# Access Compliance Report

## Public Rights-of-Way

### (Curb Ramps)

Intersection ID: 29484	Main Street: SETTLEMYER_CT	Cross Street: WILORA_LANDING_RD	Location: SE
ADA ID: 5812E54FE79C	Ramp Type: BlendTrans1	Initial Pass/Fail: Fail	Overall Compliance: No
Severity Score: 42.5			
Codes/Mitigation Info/Possible Solution		Field Measurements/Component Compliance

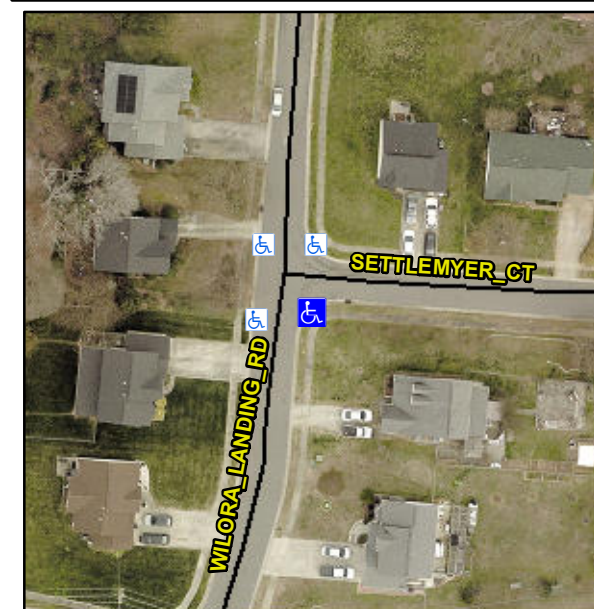
**Remove & Replace Curb Ramp With Two New Directional Ramps or Equivalent.**

**Not Found, R304.5.1, R304.5.3**
